PROJECT NO. I-H2-1(17):6

WAIHAWA INTERCHANGE

WAIHAWA INTERCHANGE
SPRINKLER PLAN
AREA "W-2"

WAHIAWA INTERCHANGE & LEILEHUA INTERCHANGE
CONTROL DIAGRAMS

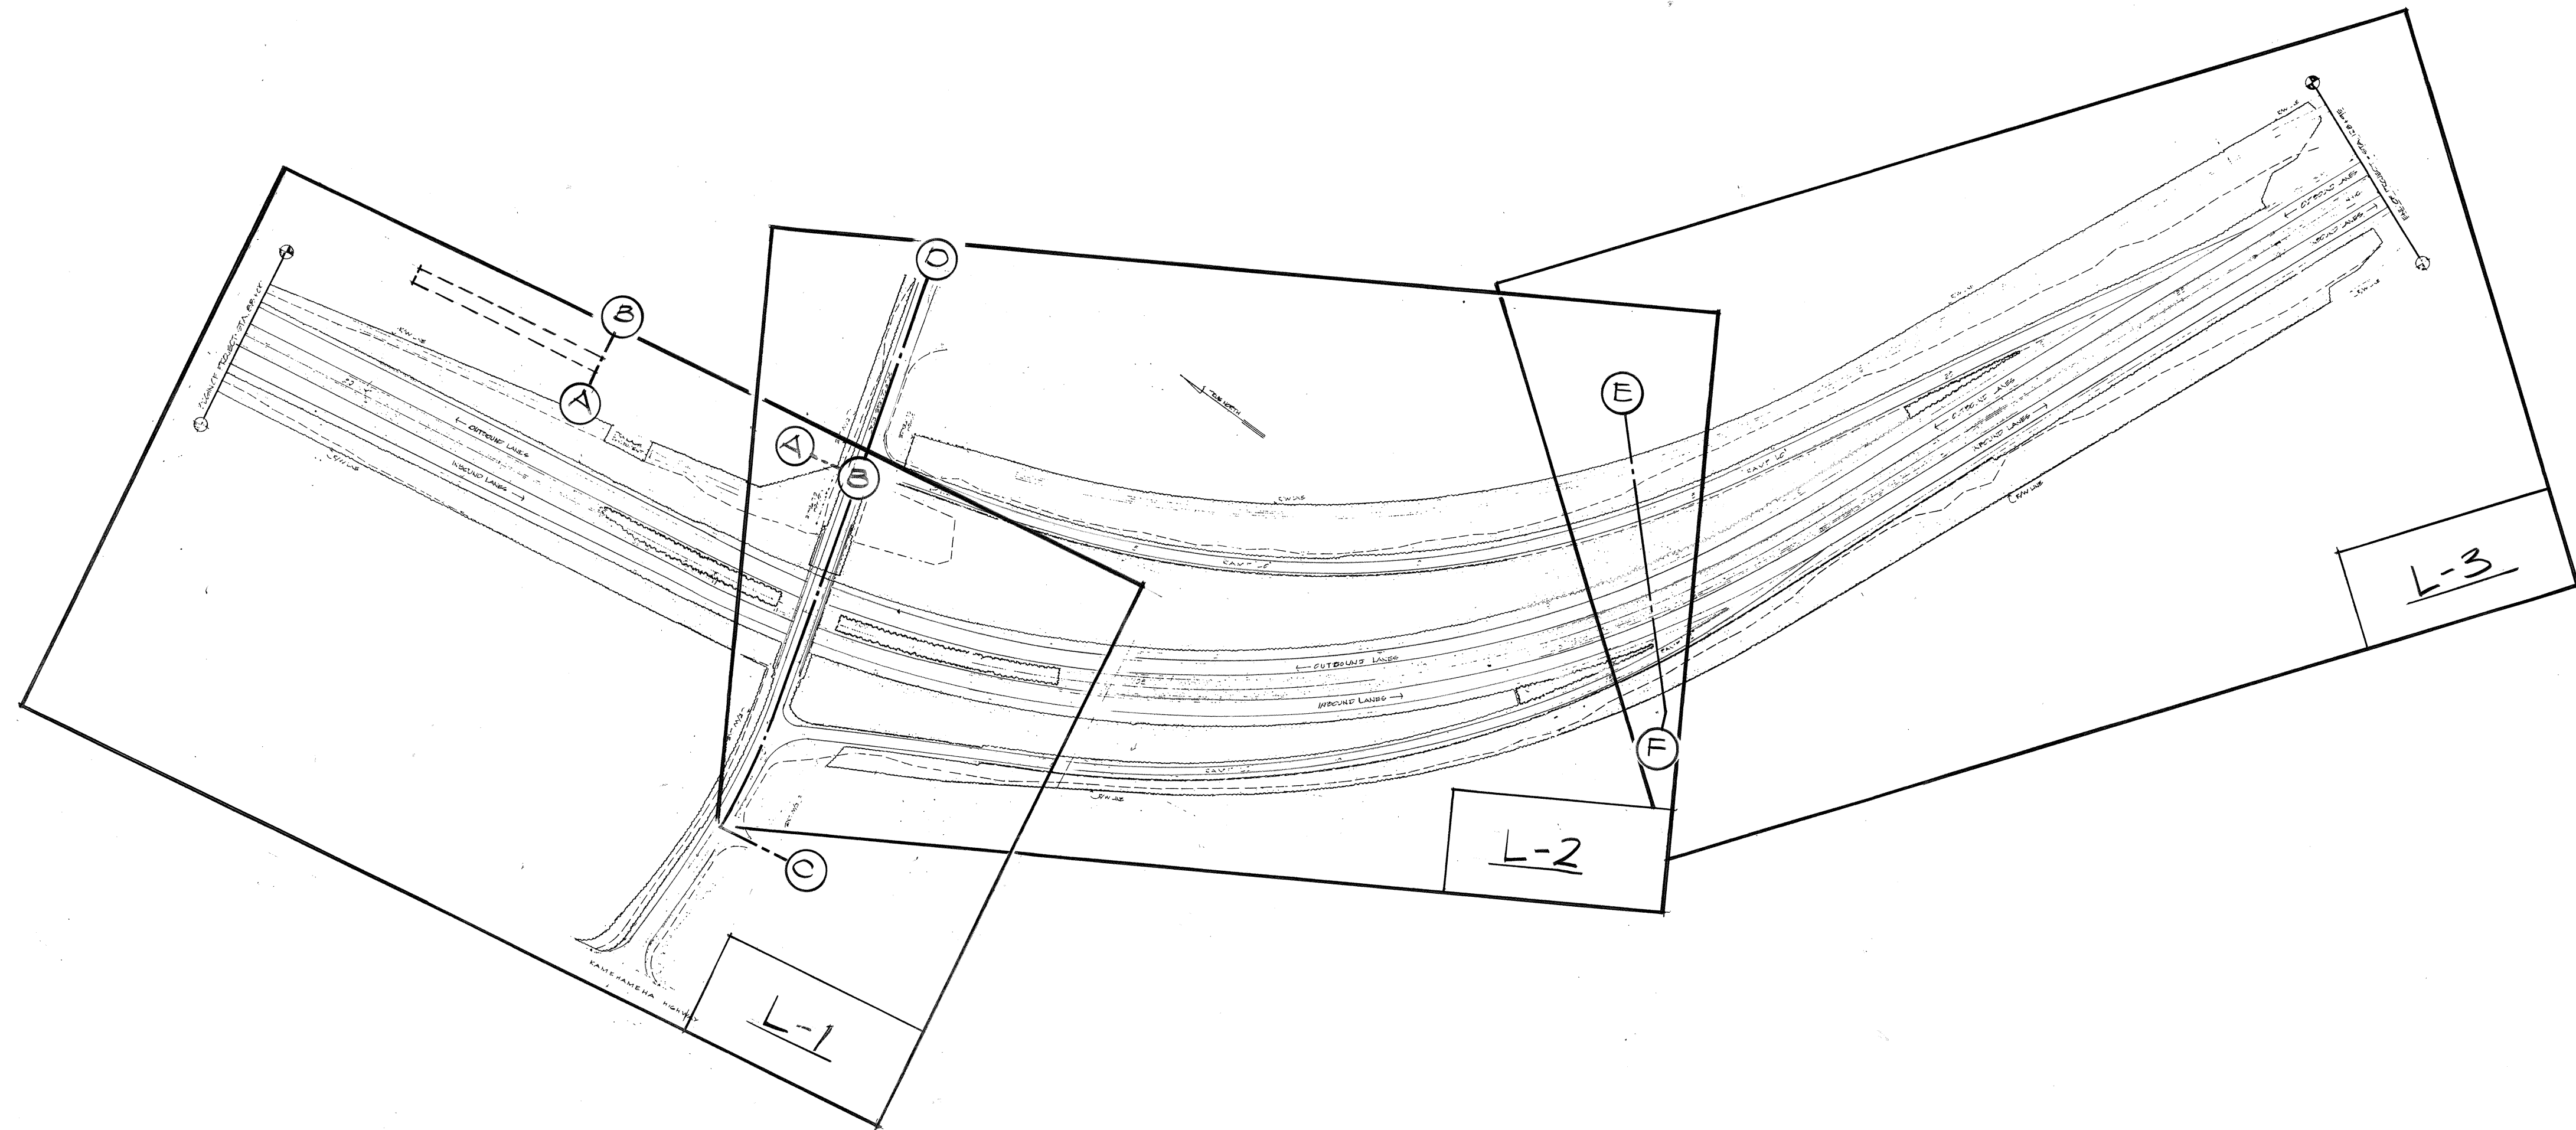
DATE	REVISION
11/18/76	Revised table for sprinkler system; revised water meter connection; revised backflow preventer; delete planting Lippia - per addendum No. 1.

GENERAL NOTES

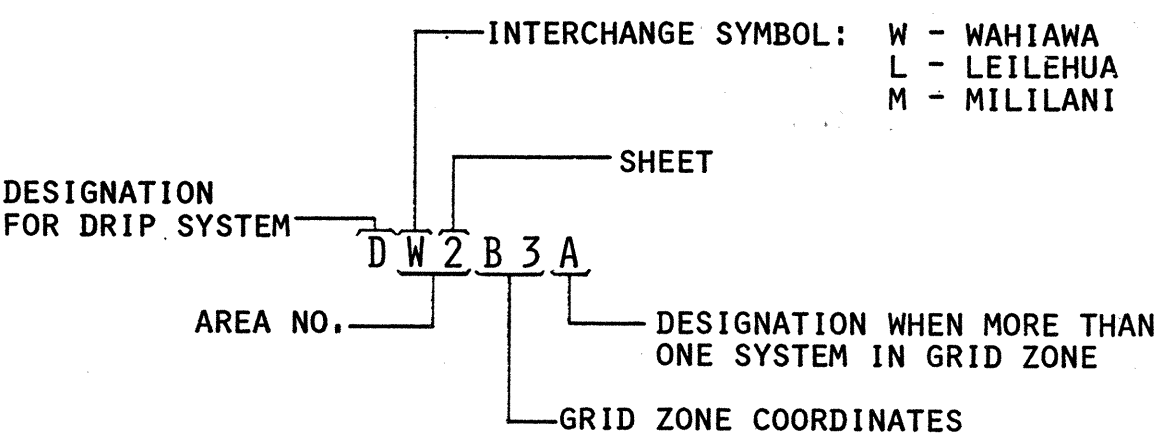
DATE	REVISION
11/18/76	Revised General Note No. 21 and Sprinkler Designation and Performance Table, per Addendum No. 1

PROJECT NO. I-H2-1(17)G
WAHIAWA INTERCHANGE
SPRINKLER PLAN
AREA "W-3"

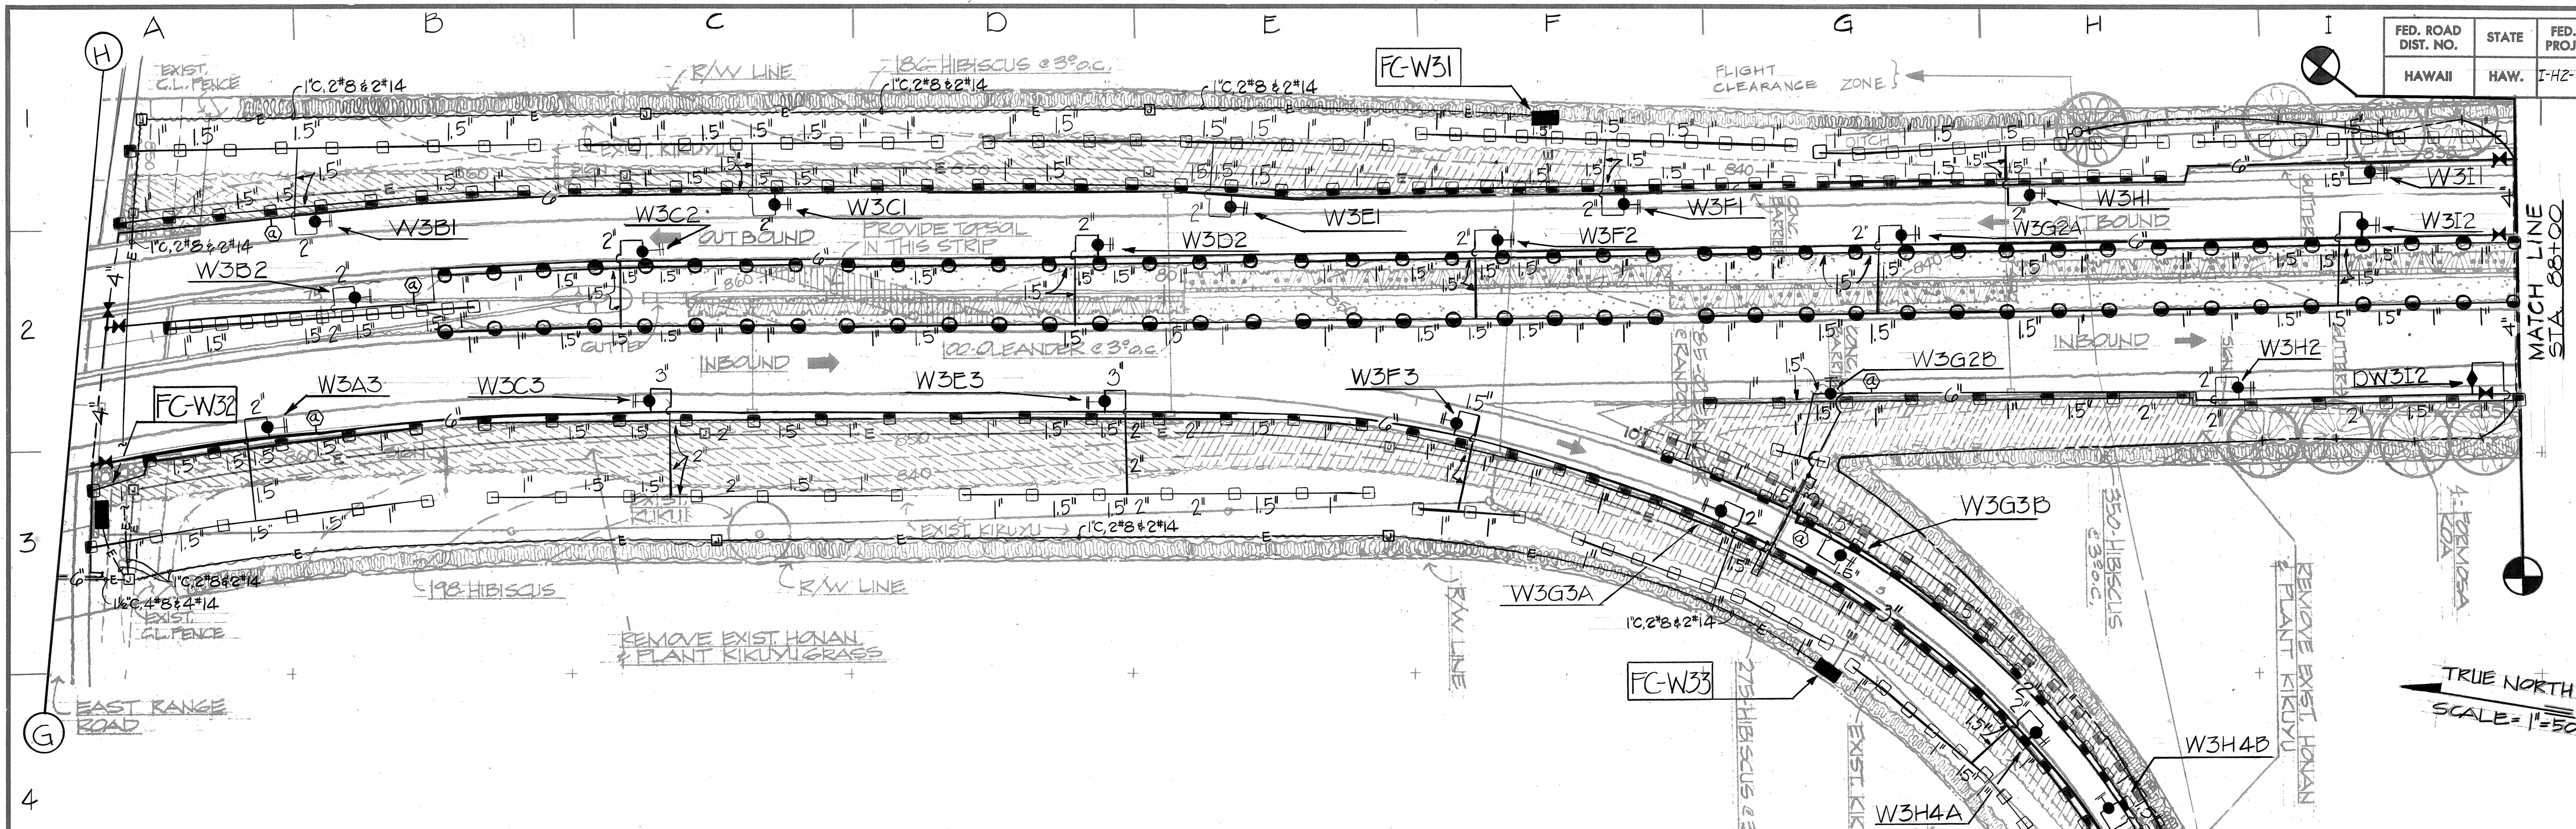
DATE	REVISION
11/18/76	Revised table for sprinkler system; delete planting Lippia - per addendum No. 1.

**LEILEHUA INTERCHANGE
SPRINKLER PLAN
AREA "L-2"**

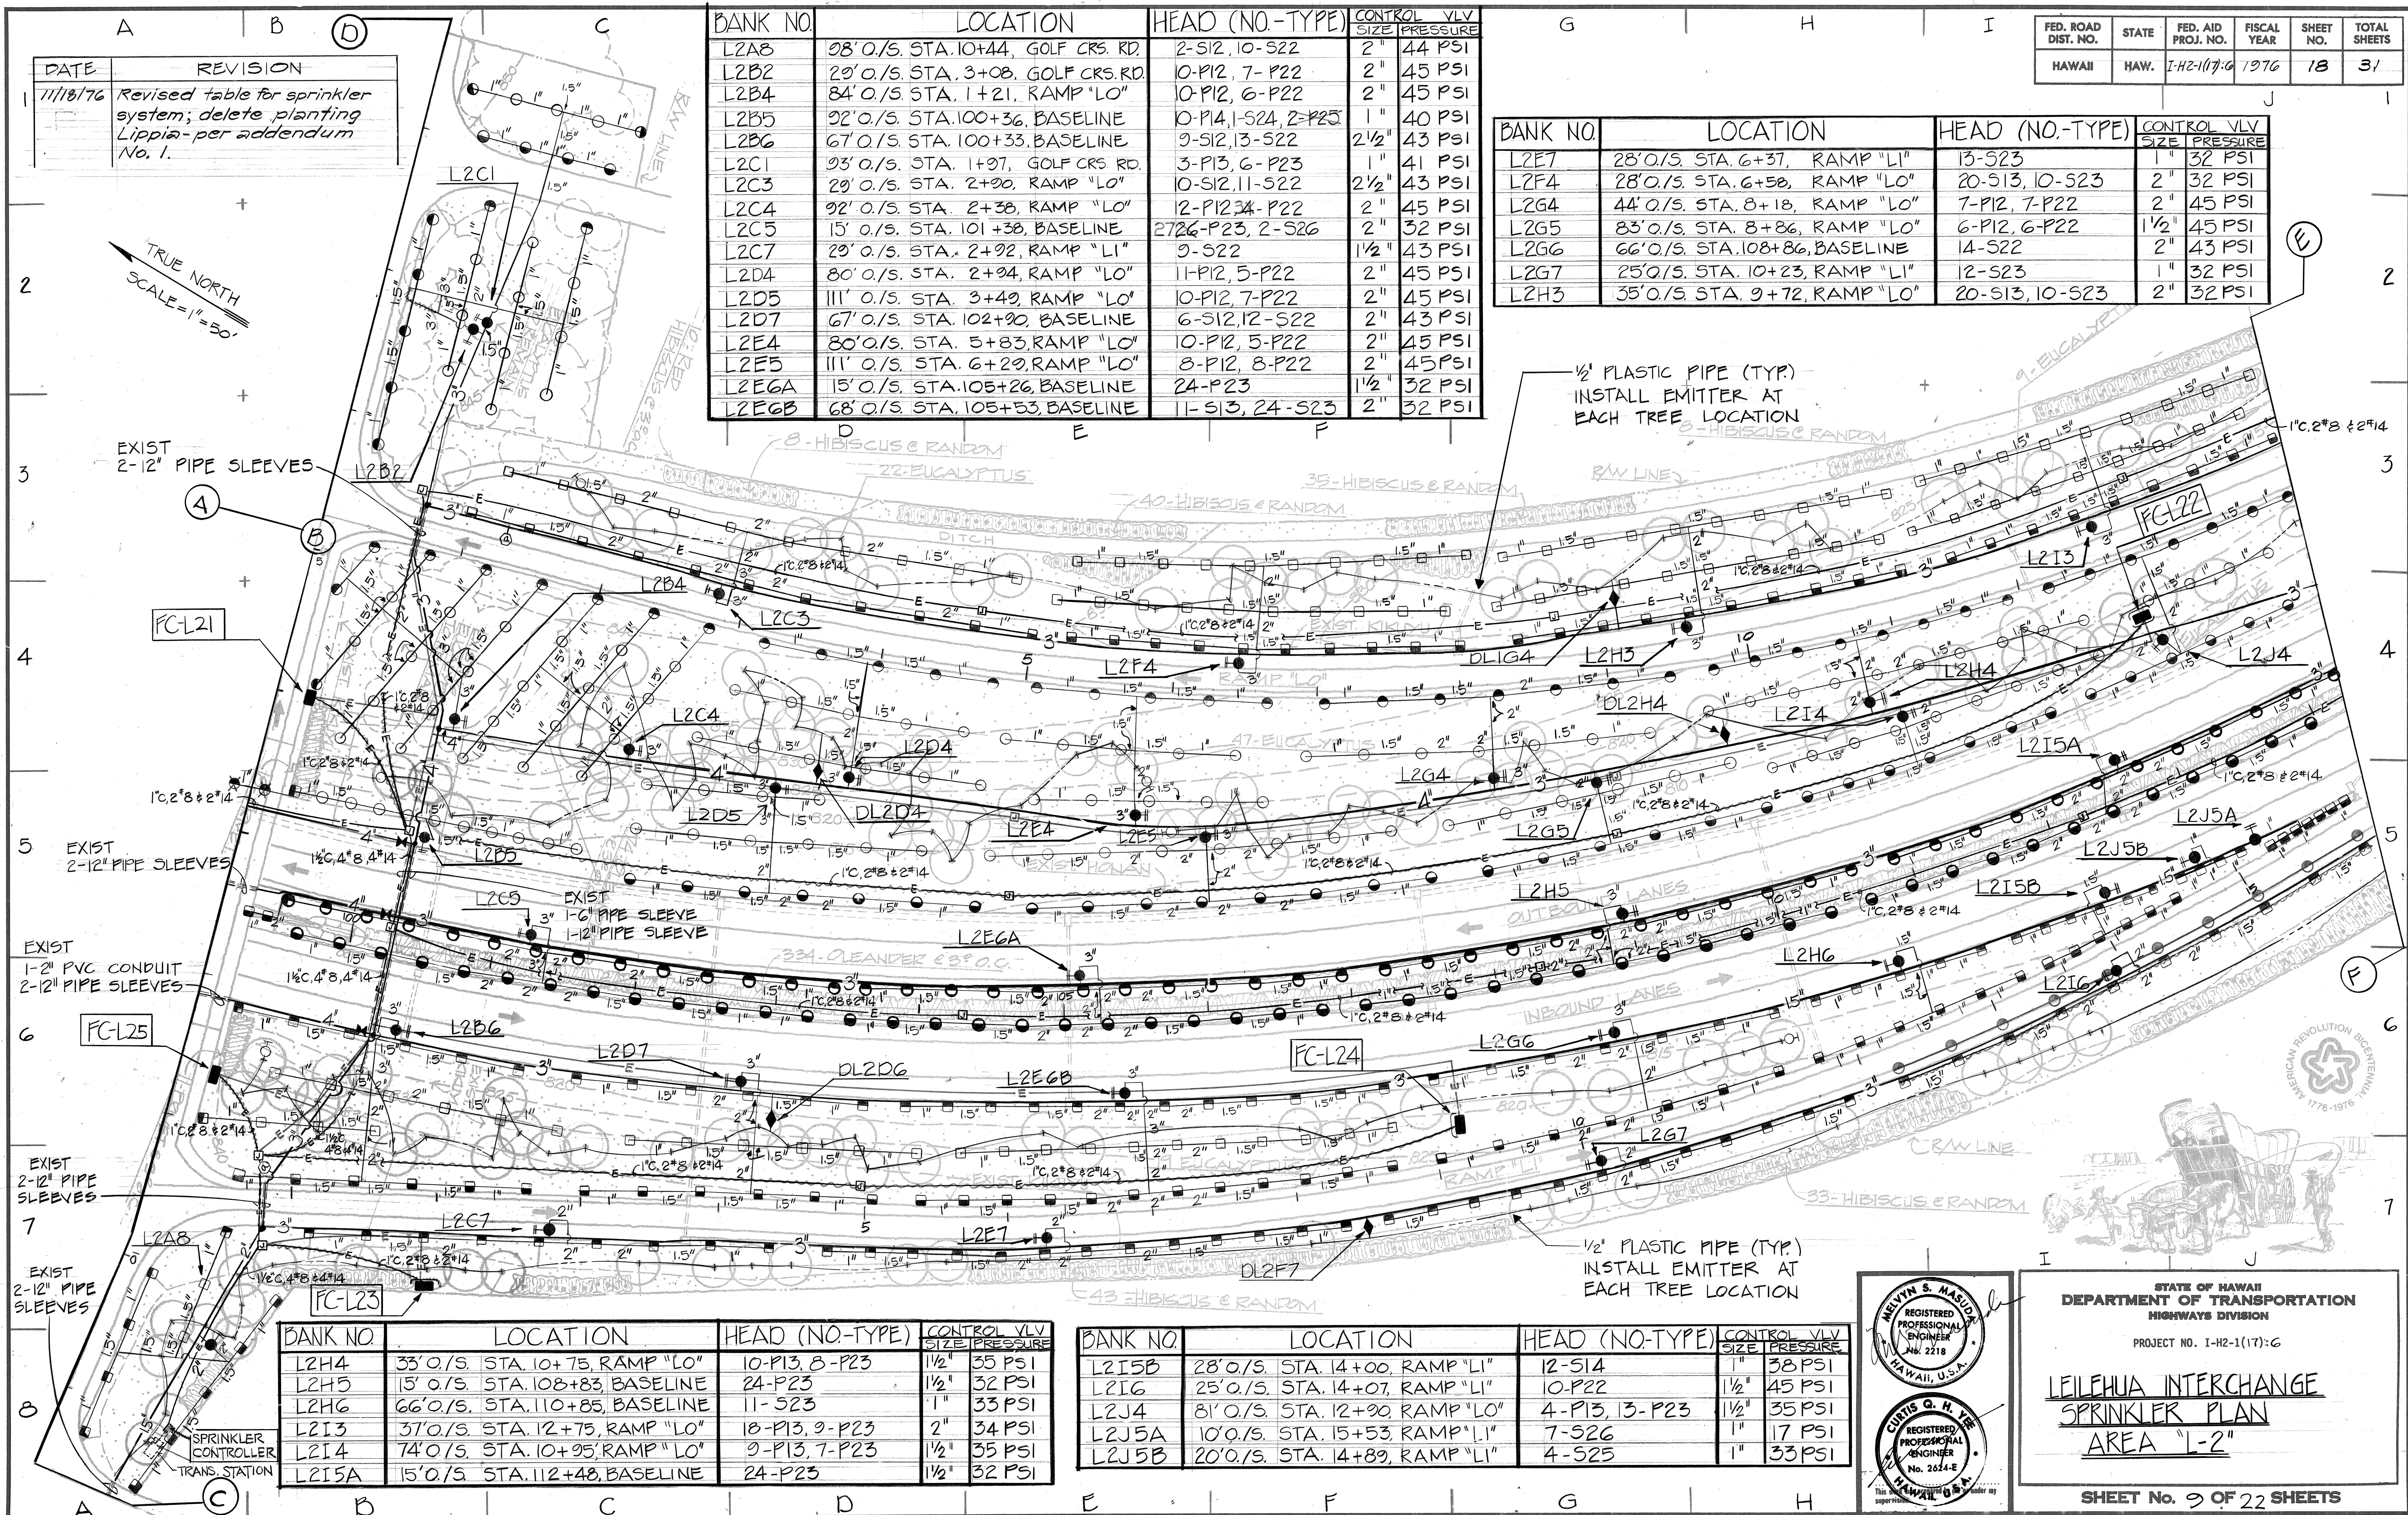
DATE	REVISION
11/18/76	Revised table for sprinkler system; delete planting Lippia - per addendum No. 1.
